462-482 Swan Street, Richmond - Peer Review

This peer review of the MEL Consultants Environmental Wind Speed Measurements report (Report No 36-20-WT-ENV-03) is based on Vipac's experience as a wind-engineering consultancy.

Figure 1 South west corner of the ground floor plan (dated 16/04/2020)

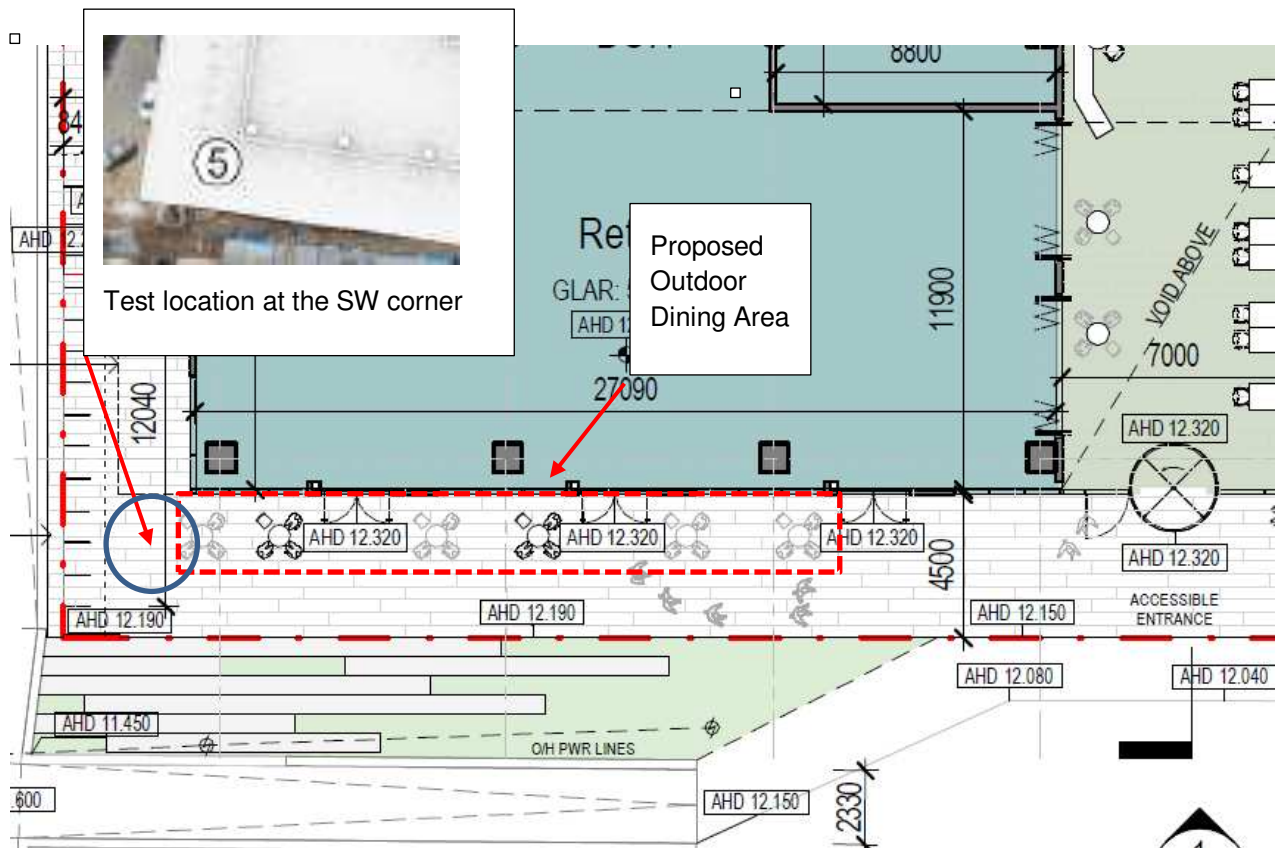
- Vipac note that there is an alfresco dining area proposed at the south side of the development close to southwest corner (see Figure 1 in the attachment). MEL Consultants test report has not assessed any outdoor seating areas. Test showed that the wind conditions at the close by location (Location 5) were within walking criterion for the updated design but well over the sitting comfort criterion. Vipac recommends that **MEL Consultants should provide additional assessment for this area.**

Vipac note that there is an outdoor seated area proposed at the south side close to southwest corner (see Figure 1 in the attachment) which was not assessed. Vipac recommends that **MEL Consultants should provide additional assessment for this area.**
